AMENDMENTS TO THE DRAWINGS

REMARKS/ARGUMENTS

This amendment is in response to the Office action mailed May 10, 2005. As of the Office action mailed May 10, 2005, claims 1-3 are pending with all claims standing rejected. Reexamination and reconsideration of the application as amended and in view of the remarks herein is respectfully requested.

FIG. 2

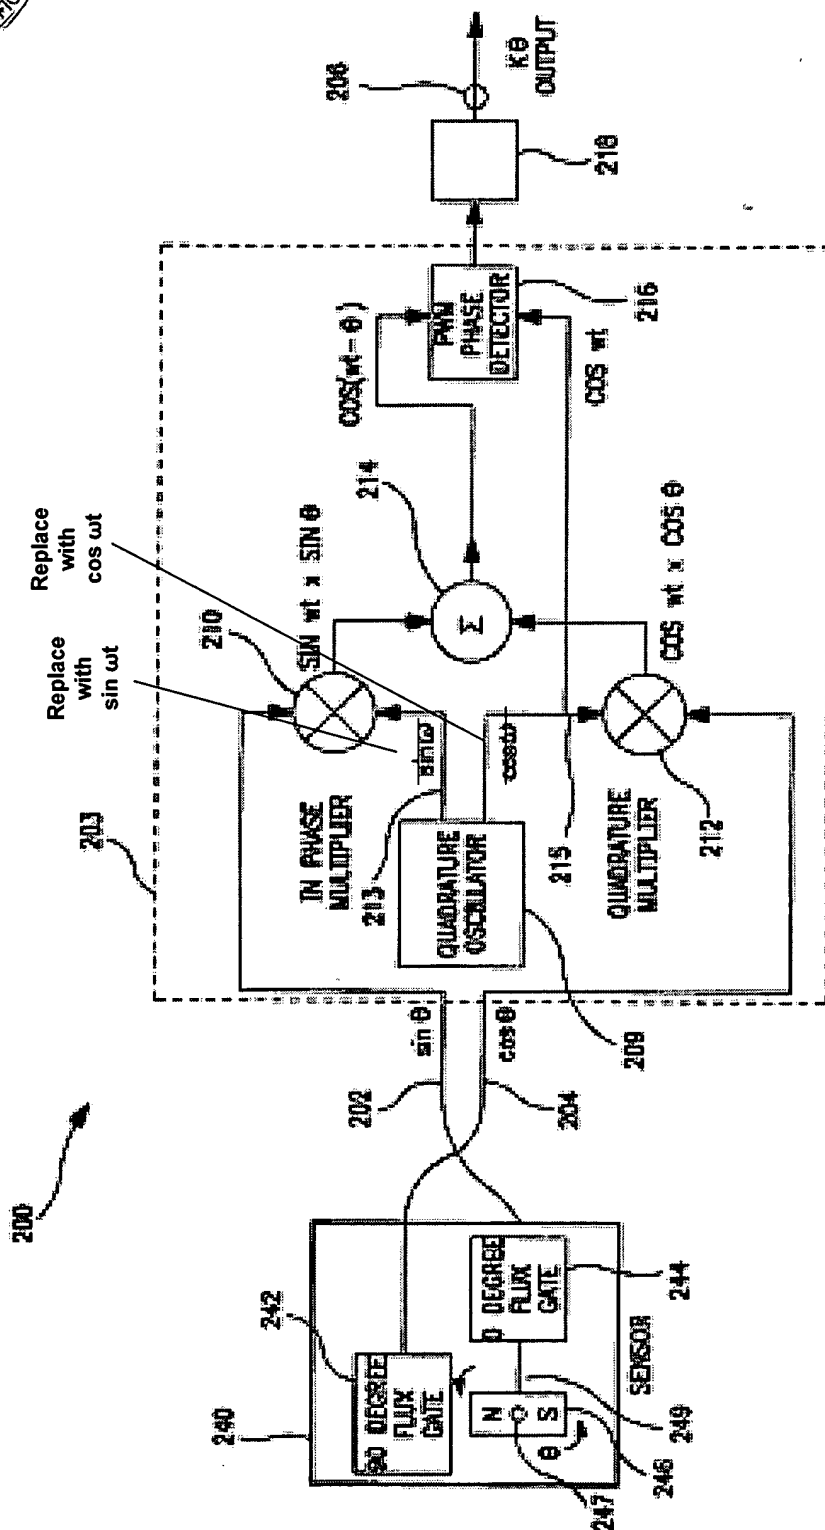
The drawings were objected to because, in FIG. 2, the outputs of the quadrature oscillator were incorrectly labeled $\sin \omega$ and $\cos \omega$. FIG. 2 has been amended herein to correctly label the outputs to read $\sin \omega t$ and $\cos \omega t$ respectively. No new matter is believed entered by this amendment.

The drawings were also objected to because the Examiner found it unclear which components in the circuit 203 comprise the modulator and which components comprise the PWM generator circuit. The application has been amended herein to consistently designate the block 203 of FIG. 2 as “phase angle pulse modulation circuit.” Accordingly, it is not believed necessary to delineate a separate modulator circuit and a separate PWM generator circuit. The objection to the drawings on this basis are believed rendered moot by the above amendment.

The attached sheet of drawings includes changes to FIG. 2. This sheet, which only includes FIG. 2, replaces the original sheet. In FIG. 2, the labels $\sin \omega$ and $\cos \omega$ have been corrected to read $\sin \omega t$ and $\cos \omega t$ respectively.
